UNITED STATES PATENT AND TRADEMARK OFFICE

APPLICATION NO.	FILING DATE	FIRST NAMED INVENTOR	ATTORNEY DOCKET NO.	CONFIRMATION NO.
10/664,575	09/17/2003	Jonathan Fanger	101896-0208	3611

Office Action Summary	Application No. 10/664,575	Applicant(s) FANGER ET AL.	
	Examiner JAMES L. SWIGER	Art Unit 3775

DETAILED ACTION

Fig. 14

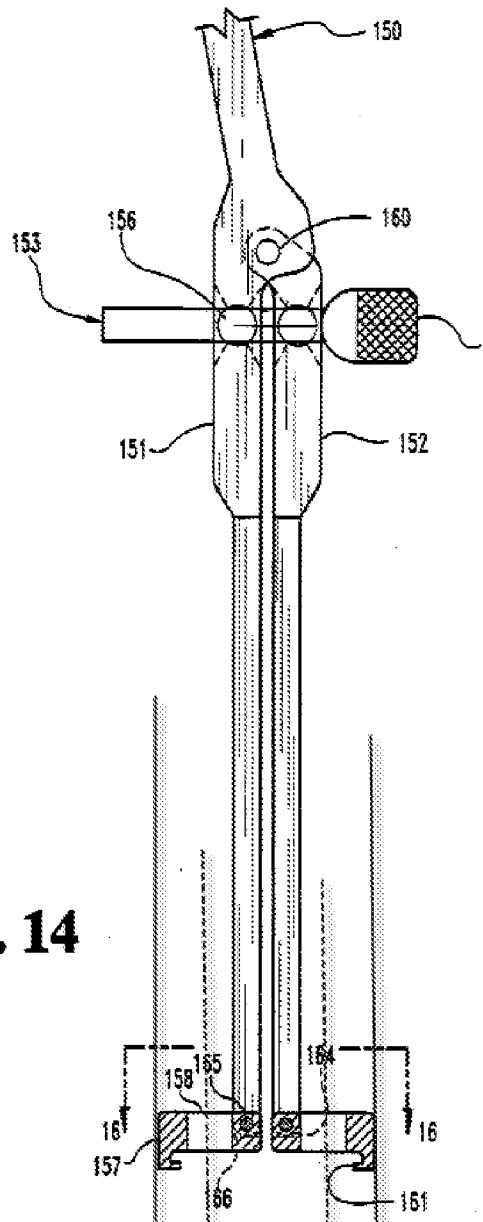
Coates discloses a guide device for use with a spinal plate comprising an elongate shaft (151/152) having a proximal (end @150) and distal ends (opposite), a guide member (157) coupled to the distal end of the elongate shaft, including first and second lumens (see 158 and opposing side in Fig. 14), extending therethrough in fixed relation to one another (in one manner, they may be in fixed relation via the adjustment knob), wherein the first and second lumens have central axes that extend in a plane parallel to opposed superior and inferior surfaces of the guide member (see annotated drawing below). The central axes are those of the guide members and the superior/inferior surfaces are shown with solid lines.

Coates further discloses first and second opposed alignment tabs (159/161) that extend distally from opposed superior and inferior surfaces of the guide member, and wherein these alignment tabs are able to non-fixedly interact with a spinal plate (see fig. 19 with plate (22)) or with an edge of a spinal plate and the guide members have the ability to flex with respect to one another, and they also prevent rotation between the

guide device and the plate. It is noted that the guide members align with the screw holes of a plate (see fig. 19). Coates further discloses at least one protrusion (170) that extends from the guide member through to the plate and is disposed within a corresponding bore. See also Fig. 19. The guide member is considered to have a shape that conforms to the shape of a spinal plate (Fig. 19 shows no/ a minimum gap between the guide member and the plate). The first and second lumens are considered to be at an angle with one another, and in terms of the above fig. 14, zero or 180 degrees are considered angles with respect to one another.

**Fig. 9**

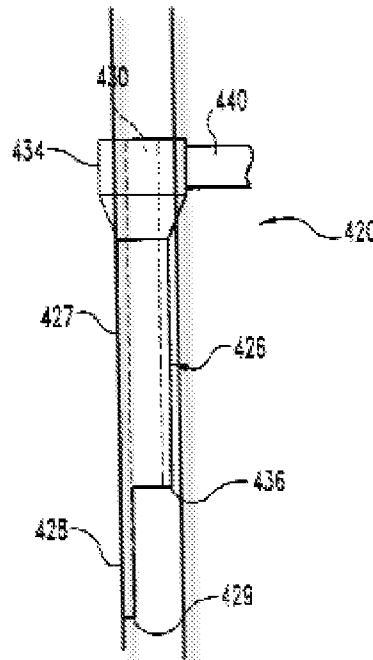
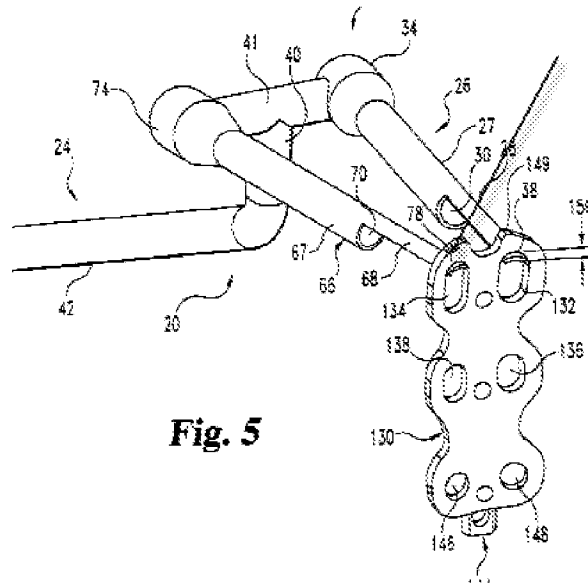
Foley discloses a device for use with a spinal plate having an elongate shaft (24) wherein the proximal and distal (end towards the spinal plate) ends are angled in relation to one another, further having a guide member (25) coupled to the distal end having first (26) and second (66) lumens extending therethrough in fixed relation (41), to one another, where the first and second lumens have central axes that extend in a plane that is parallel to opposed superior and inferior surfaces of the guide member. See drawing below. The solid lines are superior/inferior surfaces.

Foley further disclose first and second opposed alignment tabs (28/68), that are adapted to interact with a spinal plate. In an alternative interpretation Foley has at least one alignment tab that is adapted to interact with a spinal plate, wherein the other tab as

mentioned is considered at least one protrusion that extends distally and is adapted to be disposed within a corresponding bore formed in a spinal plate.

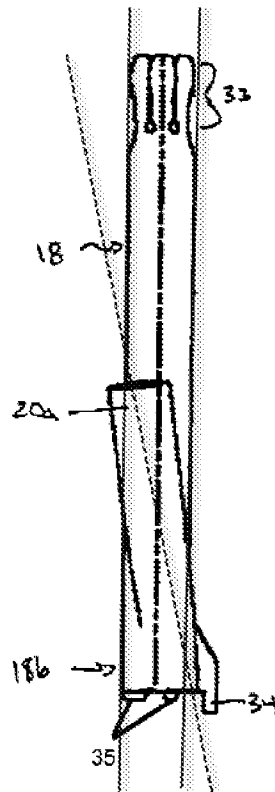
Claim 52 is rejected under 35 U.S.C. 103(a) as being unpatentable over Kolb et al. (US Patent 6,960,216). Kolb et al. disclose a guide device for use with a spinal plate having an elongate shaft (30a), having a proximal (@ approx 33) and distal ends (@ approx 30b) and a guide member coupled to the distal end (20a/20b) which has a first and second lumens extending therethrough. These lumens have central axes. Kolb also discloses at least one alignment tab (34) that is adapted to interact with a spinal plate and also protrusions (35), which are designed to fit into a corresponding bore in the plate (or detent). Kolb disclose the claimed invention except for wherein the central axes of the lumens are considered parallel to axes defined by the superior and inferior portions of the guide device. As shown below, the superior and inferior portions are in solid lines, and the central axes is dotted.

It is however noted that Kolb also teaches that the respective axes of the barrels or lumens can vary between zero and 15 degrees from this center measurement point of the elongate shaft (see Fig. 4). It would have been obvious to one having ordinary skill in the art at the time the invention was made to construct the device of Kolb having inclined axis of the guide device to the axis of the elongate shaft, as Kolb contemplates that there may be variation in plate design or surgical needs to insert screws and access the holes in a plate (Fig. 7) in a certain way.
